Service Bulletin

BULLETIN # 258B

WELDMATIC 350I/500I

REMOVAL OF SHUNT, UPDATED MAIN CONTROL PCB PWA036

The photos above show the original style PWA036 which has resistor R431 present and R132 absent.

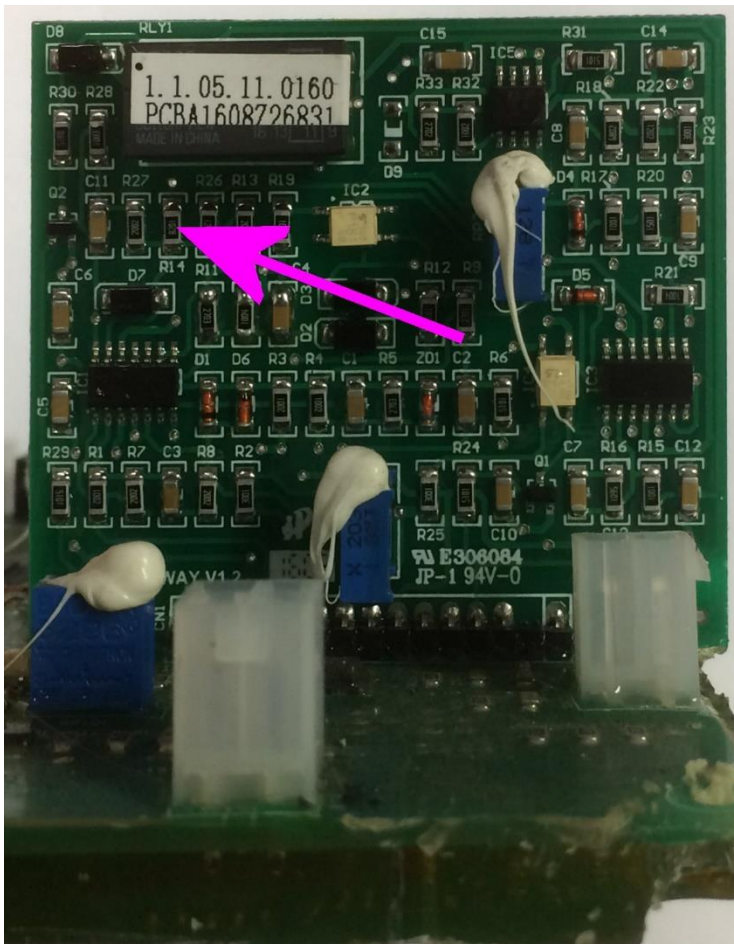
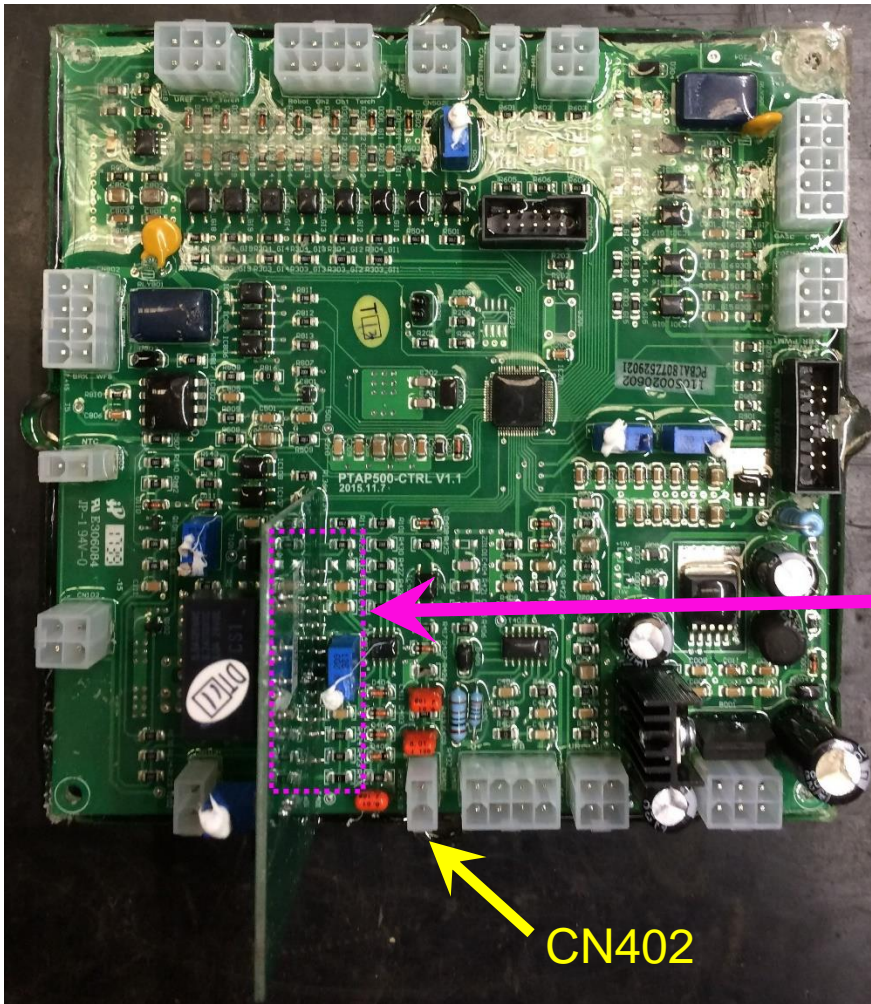
The original PWA036 has zero ohm resistor R431 present and R132 is absent.

The modified PWA036 has zero ohm resistor R132 present and 431 is absent

The modified pcb has resistor at R14 on the daughter pcb changed from 8.2k to 15k.

The photo to left shows location of R14 on the daughter pcb.

If this updated pcb is fitted to an older version machine with shunt, the current measurement circuit will ignore any signal values from the shunt and operate correctly on signals from the hall device.

It is best to leave the shunt in place, however it is strongly recommended that the wiring from the shunt is **not** connected to the Main Control pcb. This connection is normally made at CN402 (immediately to the right of the daughter board when observing from the front of the machine). To ensure that it is not connected, the plug may be cable tied back out of position or removed and wires insulated.
